JOSEPH M. FARLEY NUCLEAR PLANT, UNIT 1

AMENDMENT TO FACILITY OPERATING LICENSE

Amendment No. 106  
License No. NPF-2

ATTACHMENT TO LICENSE AMENDMENT NO. 106

FIGURE 3-4-1

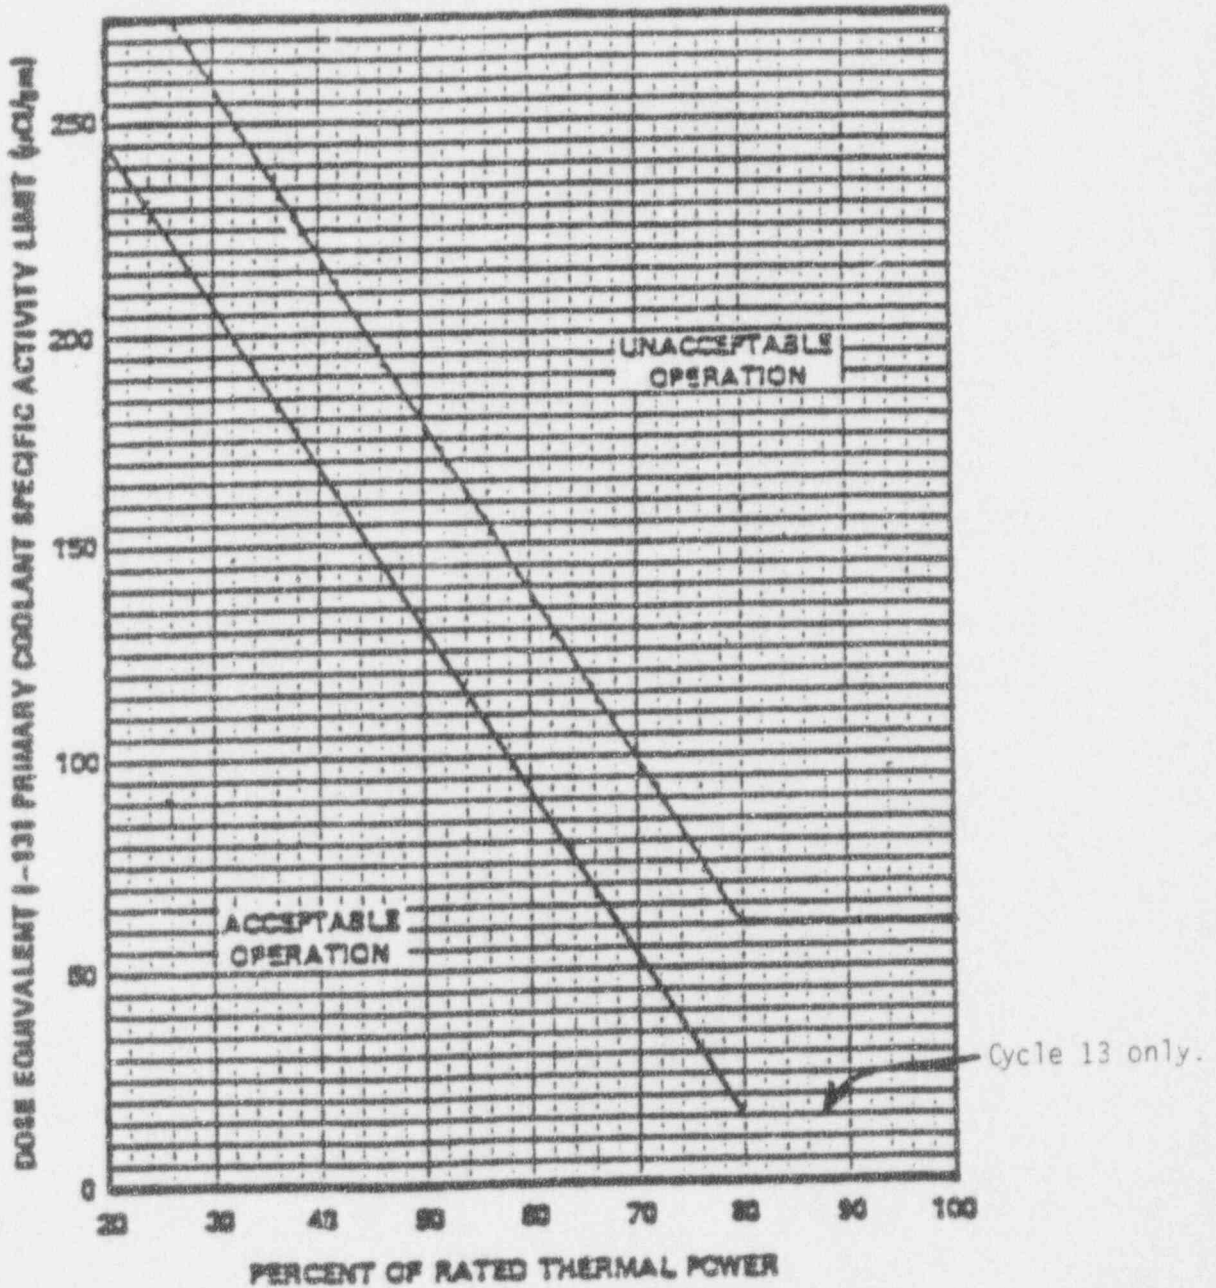
- a. For the Thirteenth Operating Cycle only, with the specific activity of the primary coolant greater than 0.25 microCurie per gram DOSE EQUIVALENT I-131 for more than 48 hours during one continuous time interval or exceeding the limit line shown on Figure 3.4-1, be in at least HOT STANDBY with  $T_{avg}$  less than 500°F within 6 hours.
- b. For subsequent cycles, with the specific activity of the primary coolant greater than 1.0 microCurie per gram DOSE EQUIVALENT I-131 for more than 48 hours during one continuous time interval or exceeding the limit line shown on Figure 3.4-1, be in at least HOT STANDBY with  $T_{avg}$  less than 500°F within 6 hours.
- c. With the specific activity of the primary coolant greater than  $100/\bar{E}$  microCurie per gram, be in at least HOT STANDBY with  $T_{avg}$  less than 500°F within 6 hours.

(Activity  $> .25 \mu\text{Ci}/\text{gram}$  Dose Equivalent I-131 for Cycle 13 only.)
